Product Change Notification

Change Notification #: 835554-00

Change Title: Intel® Wi-Fi 6E AX211 (Gig+), 2230, 2x2 AX R2

Regulatory label updates

AX211.NGWG Product Label - Before

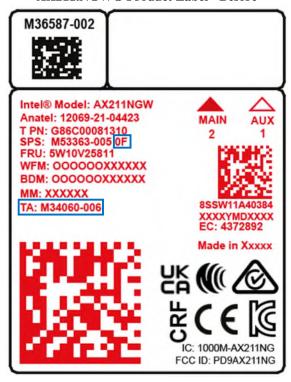
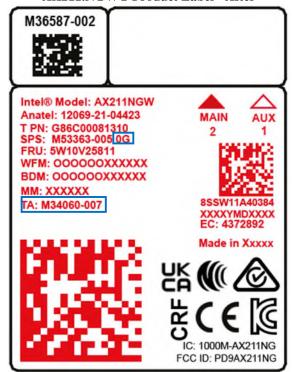
- 1. Update Japan Regulatory Certification by including 6GHz (Low Power Indoor band) on the Disti label.
- 2. Add the New Zealand R-NZ compliance marking on the Disti label.
- 3. Update Japan Giteki MIC logo on the Disti label.
- 4. Update text alignment Oman TRA product marking on the Disti label.
- 5. Update Singapore IMDA's compliance marking box on the Disti label.
- 6. Update Pakistan PTA certification marking on the Disti label.
- 7. The Intel Tracking revision will be changed on the following products.

Product Code	Before	After	
AX211.NGWG	0F	0G	
AX211.NGWG.NV	0F	0G
